Agency Report

Analysis of the Consultation Document on the Gas Transmission Tariff Structure for France

NRA: Commission de Régulation de
l'Énergie

4 December 2019

Figure 2: Calculation of distance for the cross-system flows associated with the Pirneos IP.

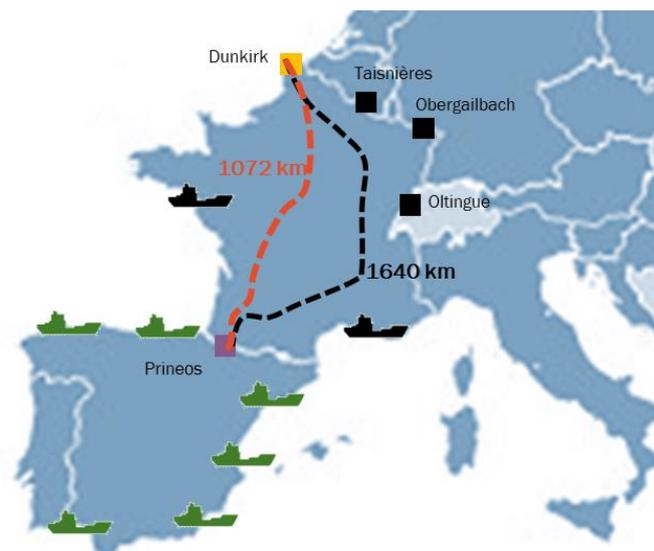
- (40) In the case of the exit point to Spain, the distance used as an input to the methodology is 1072 km, i.e. the shortest distance between the Dunkirk entry IP and the Pirineos exit IP to Spain. CRE proposes to discard LNG from the calculation of distance based on the same arguments applicable to the cross-system flows to Italy. In addition, the entry points from Belgium, Germany and Switzerland are also excluded from the calculation. Figure 2 below presents the various entry points of the French network and the one used for the calculation of the distance input for the cross-system flows to Spain.

- (52) First, the flow scenarios proposed for cross-system flows are based on the distance from the Dunkirk entry point. To justify this choice, CRE excludes certain combinations of entry and exit points to calculate the distance associated to cross-system flows. The Agency recommends that CRE clarify, in its motivated decision, the extent to which these combinations of points do not reflect the use of the transmission system for cross-system purposes. In particular, CRE should clarify in more detail and based on a quantitative assessment:

- Why the entries from LNG, the entry from Belgium and the entry from Germany are not relevant for flowing gas to the exits to Spain and Switzerland. The Agency recommends that CRE provide a quantitative analysis demonstrating the lack of competitiveness of these routes when excluding them based on the potential existence of more competitive alternative routes.

- How and to what extent firm cross-border exit capacities towards Italy and Spain rely on the flows from the Dunkirk IP. For this analysis, the Agency suggests that CRE compares historical data of flows at Dunkirk and at cross-border exits.
